Network PTZ Dome Camera Firmware

Version: V5.5.0

Release Note

2.1 Device Parameters Information Export

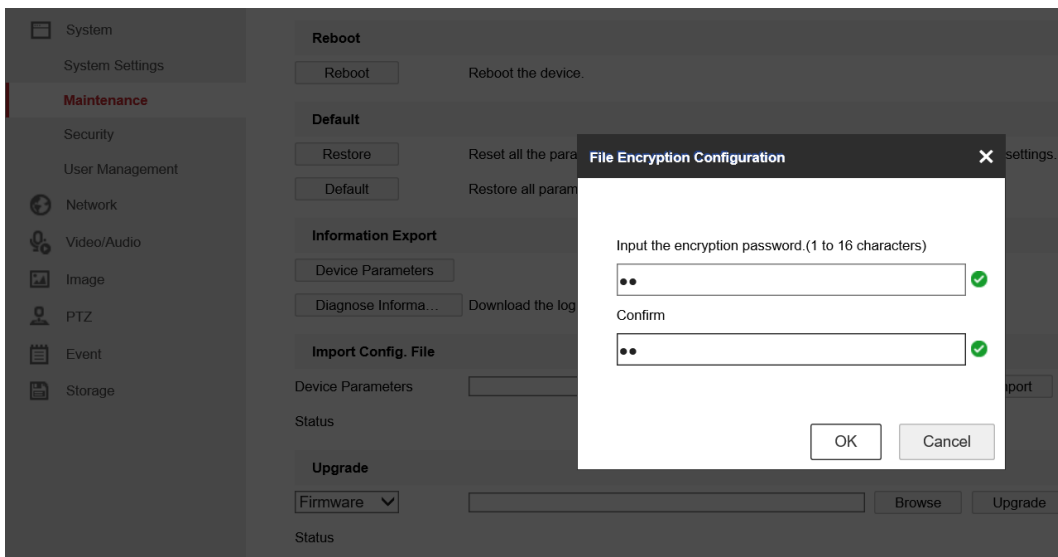
The password is needed when import or export Device Parameters from Web or 4200 client. The length of password is from 1~16 bits, numbers or letters are permitted.

2.2 Modify ONVIF and CGI

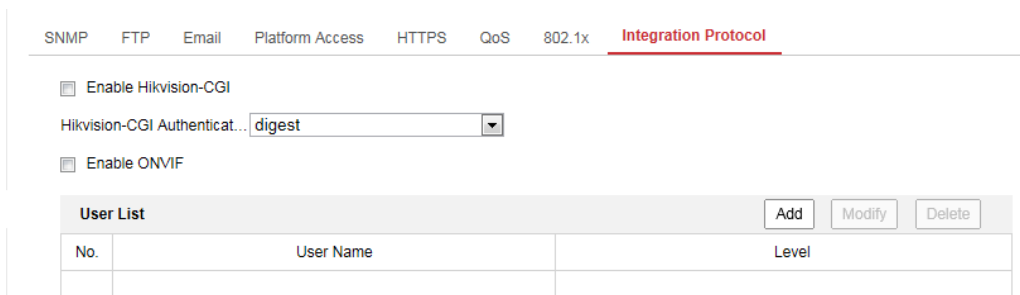
- 2) User management system in ONVIF is independent from device. Add user types, including Media user, Operator and Administrator, Up to 32 users. The password level of ONVIF user is consistent with device user.

2.3 Hik-Connect

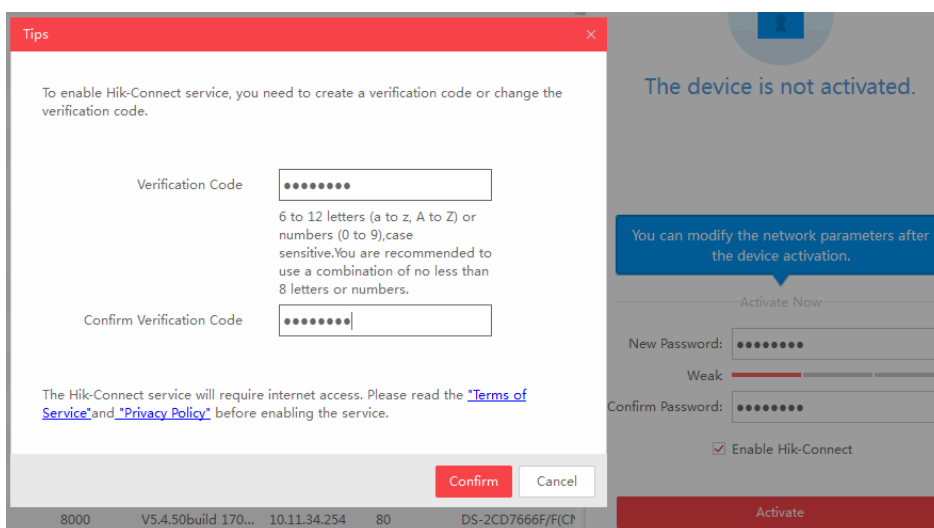
1. The ezviz name of baseline device is "Hik-Connect" and domain name is dev.hik-connect.com; the ezviz name of neutral device is "Guarding Vision" and domain name is dev.guardingvision.com.
2. DF series, DY series and ZOOM Camera series don't support HIK-Connect, DE series support HIK-Connect, and HIK-Connect is disabled by default.
3. SADP, 4200, 5200, 4500 and HIK-Connect client support to open Cloud P2P when active new device, you can also create verification code at the same time.

4. You can also open Cloud P2P by web interface or client, there will be a notice to let you create Verification code, the verification code is visible.
If the factory equipment already have the verification code, the device will reminder you to

3.3 Diagnose Information Export

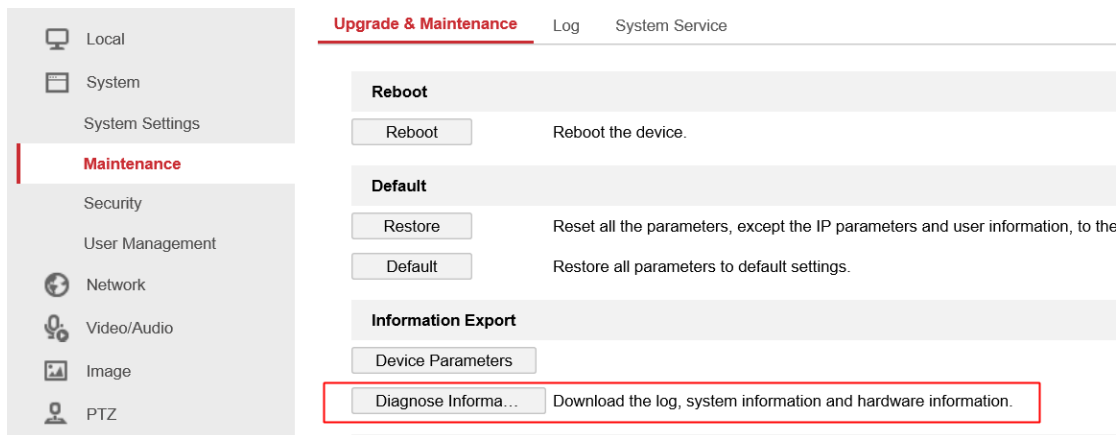
- 1) All devices of Version 5.5.0 support export **Diagnose Information**, the filename format is “Serial No._current time.txt”.
- 2) The exported information includes, but is not limited to, netstat, ifconfig, stack information, ft information, Device start-up time, routing table, ps, taskShow, meminfo, getpreviewStatus, dspStatus, getUserOnlineInfo, hardware information.

3.4 Local password reset

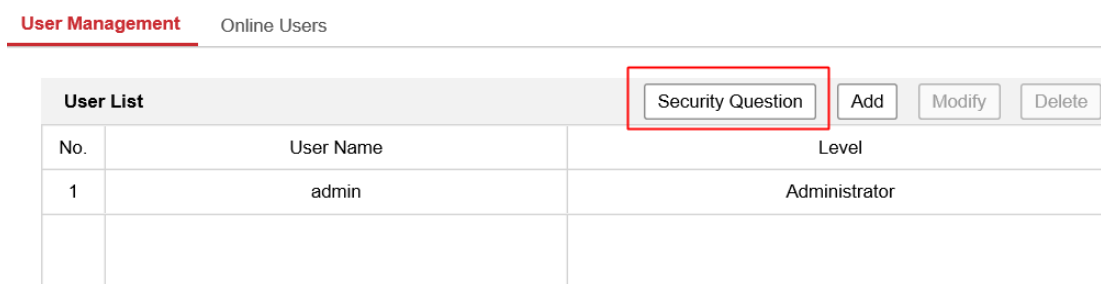
- 1) Support Security question in order to help customers get back passwords that might have forgotten
- 2) In order to ensure safety, reset password operation must be in local area network
- 3) User can create 3 common questions, there has 10 optional questions.

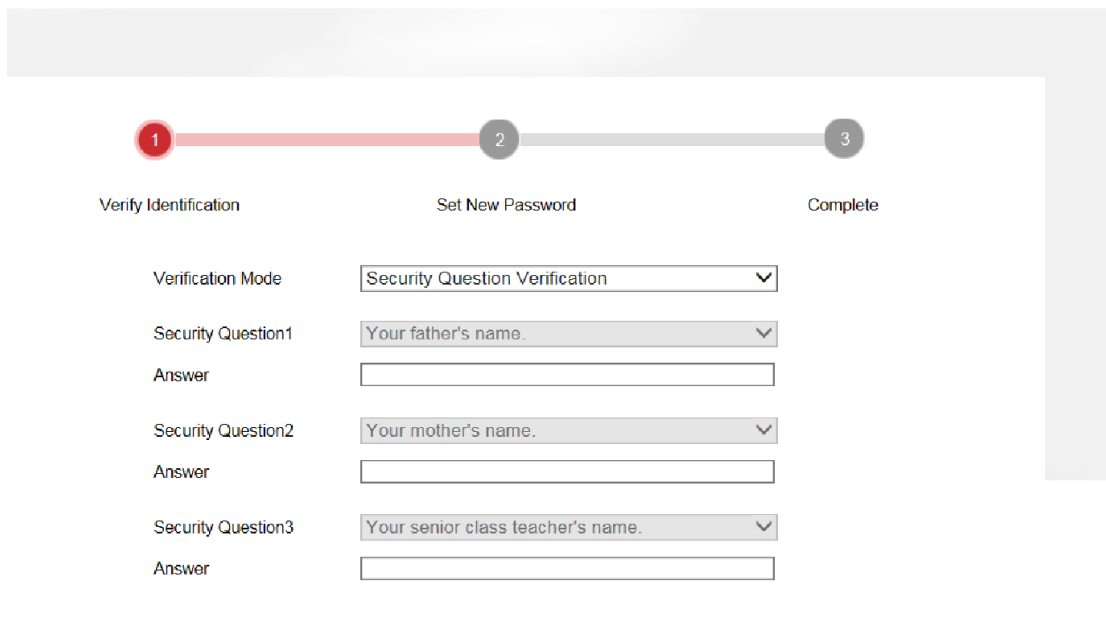
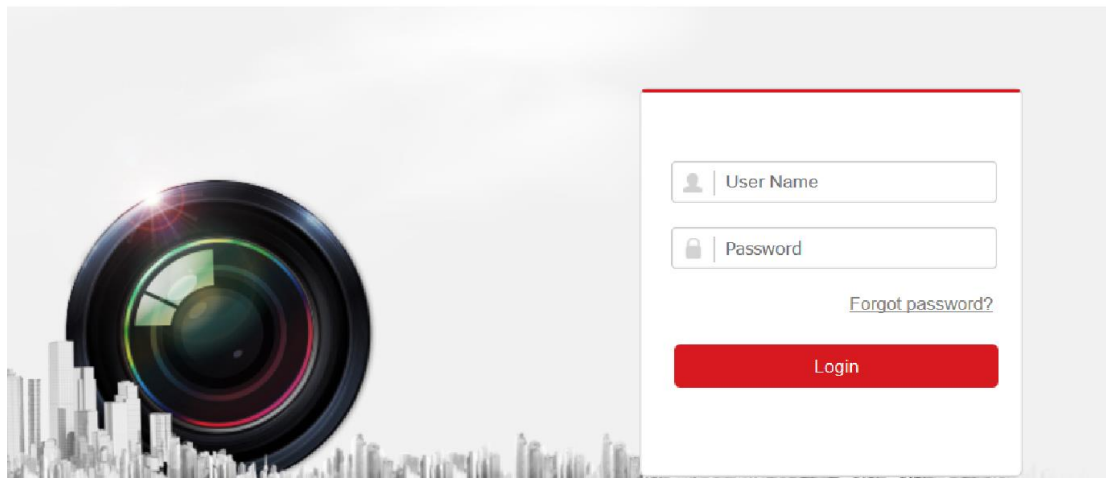
- 4) At the Login interface, you can click "Forgot password" to input the answers to the questions

5) SADP client support set **Security Question** when active new device.

4.6 Change HTTPS

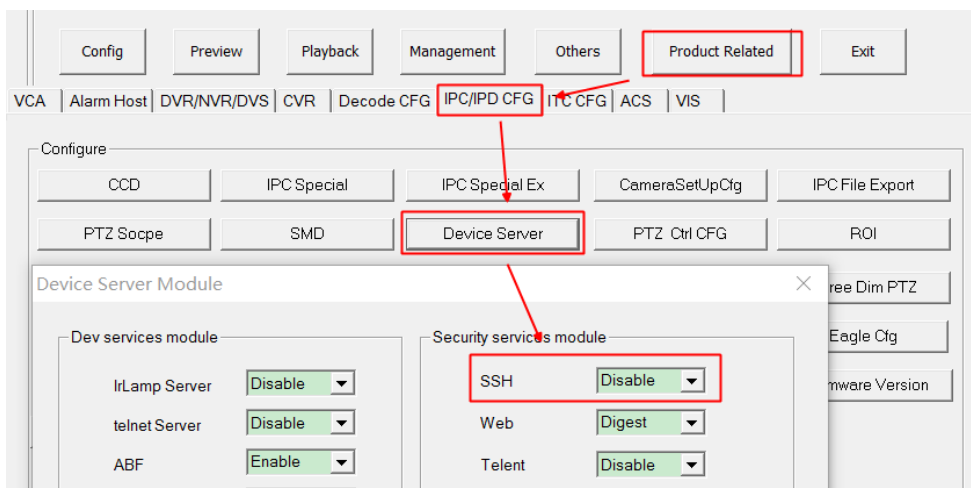
- 1) Delete https certification and reboot device, which won't create certification automatically.
- 2) Secret key length of HTTPS certification is change from 1024 to 2048.
